Work Order ID 89018

Item Name: Crosstube Fwd

Reference: NCR 12-1695

DART SERVICE INSTRUCTION

FIGURE 1 - GROUNDING STRAP INSTALLATION
(VIEW LOOKING FWD)

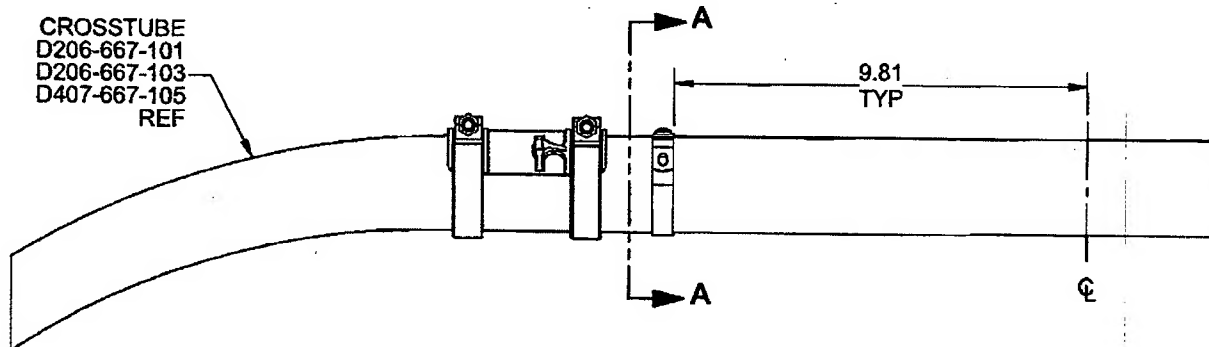
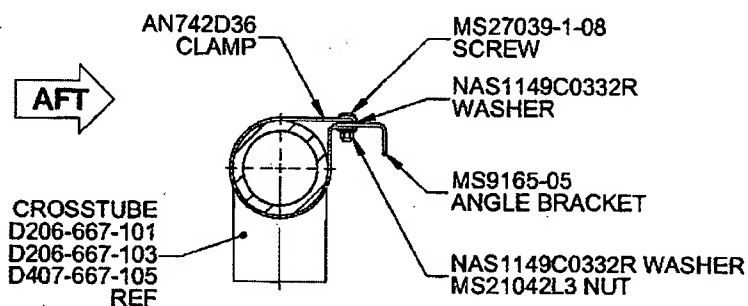
- 1) If installed, follow Section 32.1 of ICA-D206-667 for removal of the forward crosstube from the helicopter.
- 2) Locate AN742D36 Clamp as shown in Figure 1 of this service instruction and mark location of clamp on the crosstube.

- 4) Install AN742D36 Clamp complete with MS9165-05 per Section A-A of Figure 1 of this service instruction.
- 5) Touch up paint as required per Item 5.3.3 of ICA-D206-667.

SECTION A-A
(SUPPORT, CLAMP, CUSHION NOT SHOWN FOR CLARITY)
TYP, 2 PL PER CROSSTUBE
